Model: Triton-C1 ADF (DF81)		Date: 3-Jun-05	No.: MB721001
Modified Article: Grounding Tape		Prepared by: M. Tsuyuki	
From: 1st Tech. Support Sec. Service Support Dept.			
Reason for Modification:	<input type="checkbox"/> Parts catalog correction <input type="checkbox"/> To facilitate assembly <input type="checkbox"/> Part standardization	<input type="checkbox"/> Vendor change <input checked="" type="checkbox"/> To improve reliability <input type="checkbox"/> Other	<input type="checkbox"/> To meet standards ()

Model: Triton-C1 ADF (DF81)		Date: 2-Aug-05	No.: MB721002
Modified Article: Holder Pad Etc.		Prepared by: M. Tsuyuki	
From: 1st Tech. Support Sec. Service Support Dept.			
Reason for Modification:	<input checked="" type="checkbox"/> Parts catalog correction <input type="checkbox"/> To facilitate assembly <input type="checkbox"/> Part standardization	<input type="checkbox"/> Vendor change <input type="checkbox"/> To improve reliability <input type="checkbox"/> Other	<input type="checkbox"/> To meet standards ()

Model:DF81		Date: 28-Aug-06	No.: MB721003
Modified Article: SNR:ROM_512KBIT:6LE68179000		Prepared by: Y.Murata	
From: 1st Tech. Support Sec. Service Support Dept.			
R

1. ASM FEED

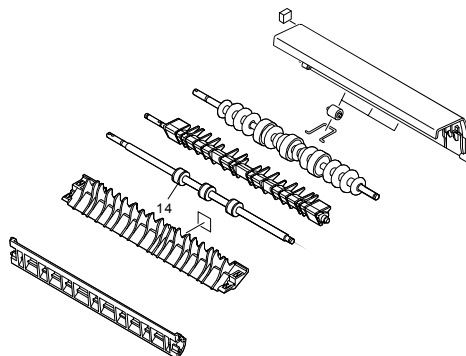
Change/Reason: The Parts Catalog was corrected as follows.

Old part number	New part number	Description	Q'ty	Int	Page	Index
B7211030		Holder Pad (4408090680)	1->0		3	30
B7211032		Pad (4408692190)	1->0		3	32
B7211033		Mylar Hld Pad (4408690730)	1->0		3	33
B7213014	B7213214	Roller Exit (4408691210) Roller Exit (4408694720)	1	X/O	7	14
B7215102	B7215152	Spring Ass'y (4408691820) Spring Ass'y (4408693020)	1	X/O	13	3
